AMENDMENTS TO THE DRAWINGS

S/N 10,713,437  
ANNOTATED SHEET

**REMARKS**

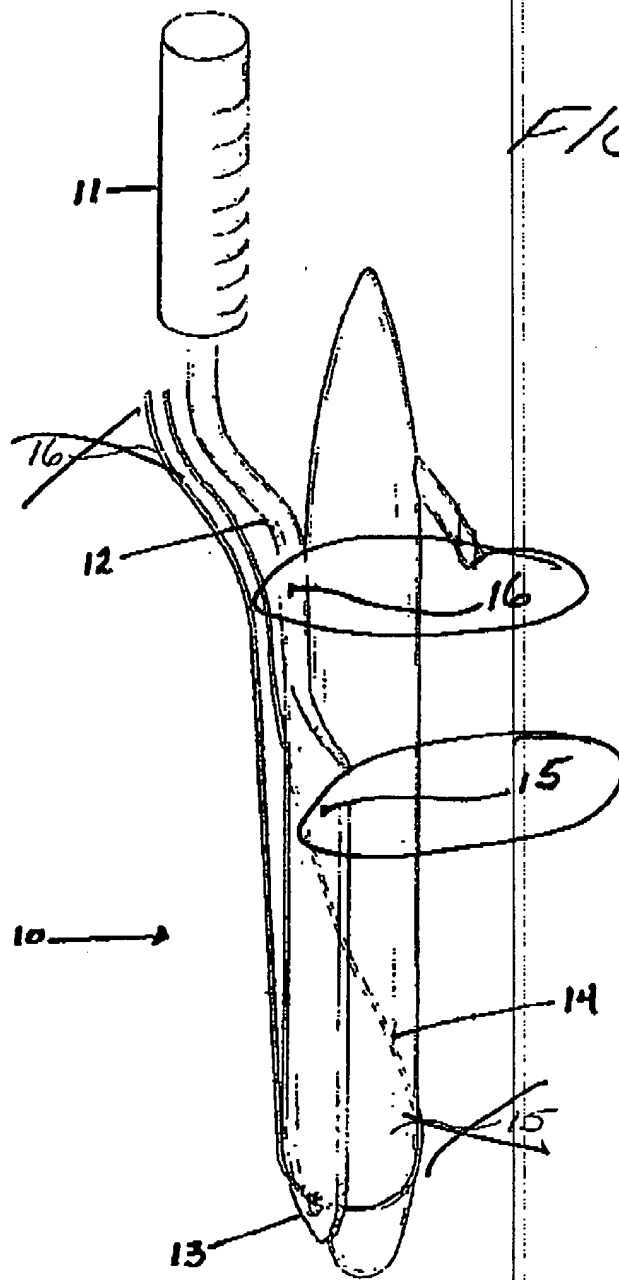
Fig. 1 has been amended to include additional item numbers that correspond with the description amended in the specification. Specifically, item numbers 15 and 16 have been added to Fig. 1, wherein item number 15 is the outwardly angled shaft section and item number 16 is the linear handle section.

Applicant has amended Fig. 1 to include additional item numbers that correspond with the description amended in the specification. Specifically, item numbers 15 and 16 have been added, wherein item number 15 is the outwardly angled shaft section and item number 16 is the linear handle section. The location of item numbers 15 and 16 have changed from the last amendment. The outwardly angled shaft section 15 is outwardly angled from the center line of the linear handle section. The portion of the outwardly angled shaft section 15 that is visible on Fig. 1 is replicated on the other side of the tool, and together, the outwardly angled shaft section and its replicate form a convexity, or a roundness in the tool so that it may fit over the rounded prosthesis. Applicant submits that the drawings should now be clear and requests that the objection to the drawings be withdrawn.

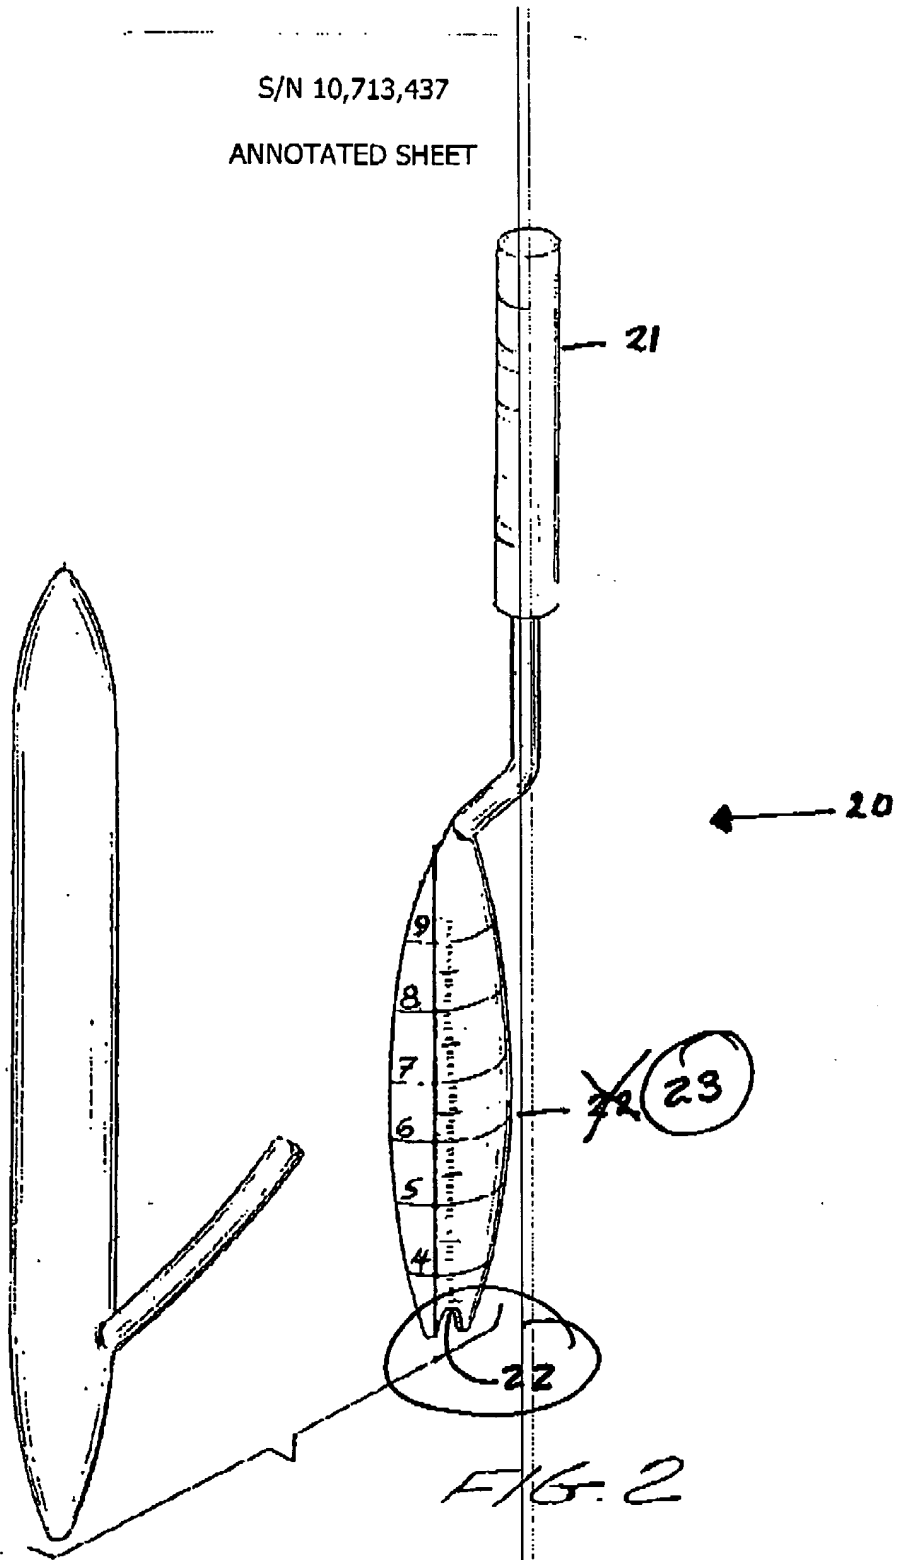
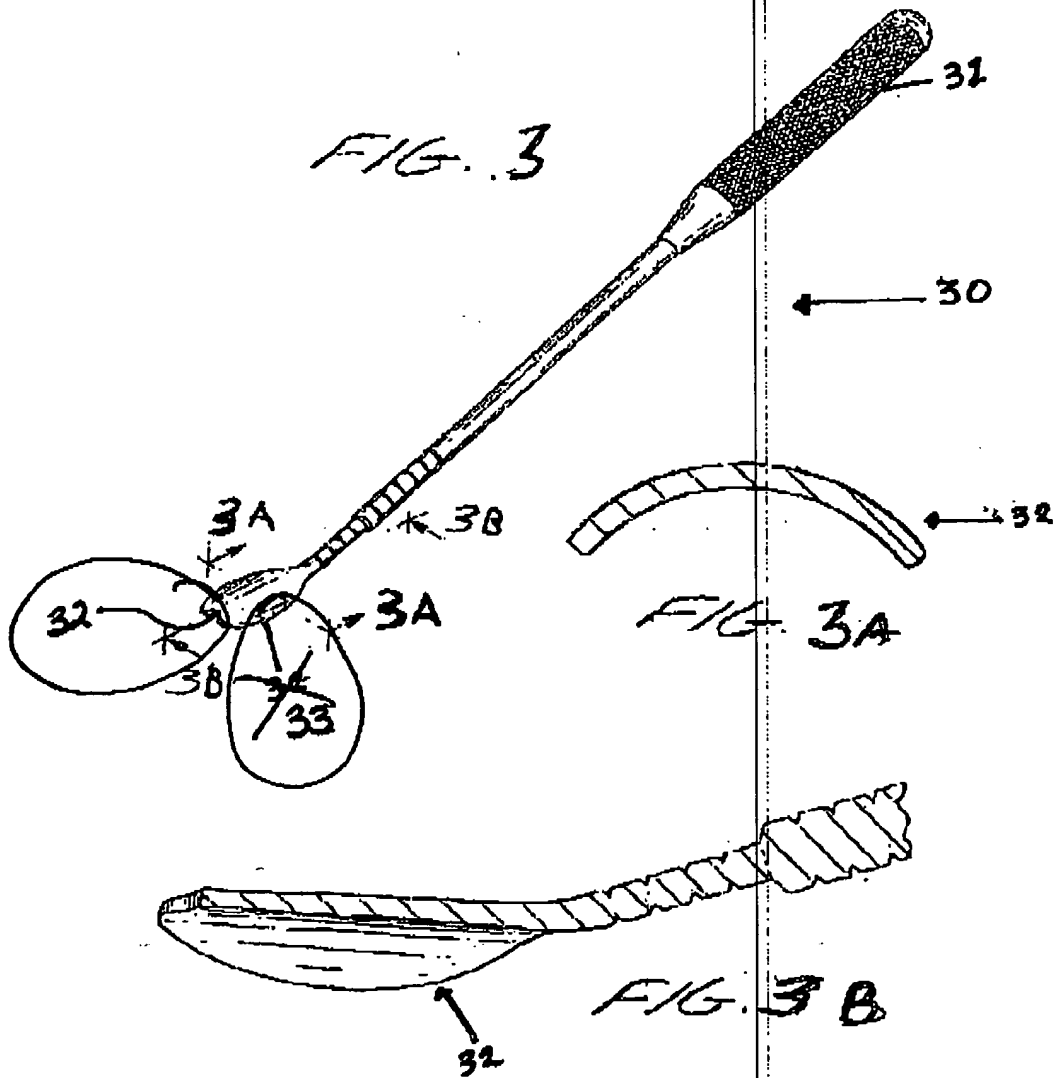
Figs. 2 and 3 have been amended to include additional item numbers that correspond with the description amended in the specification. Specifically, item numbers 23 and 33 have been added to identify the shaft. Item numbers 22 and 32 have been moved to point more particularly to the receptacle (notch) of the tool.

Applicant has amended Figs. 2 and 3 to add item numbers 23 and 33 which identify the shaft, in cooperation with the amendment to the specification presented above. Item numbers 22 and 32 have been moved on the drawing to show that they refer to the notch, or receptacle, at the end of the shaft of the tool.

Claim 6 has been rejected under 35 USC § 112, second paragraph, as being indefinite. The specification and Figs. 2-3 have been amended to better clarify the exact location of the shaft and the exact location of the receptacle, i.e., the notch at the end of the shaft of the tool. These amendments should then help to clarify the claim language as well. As such, applicant requests that the rejection of claim 6 under § 112 be withdrawn.
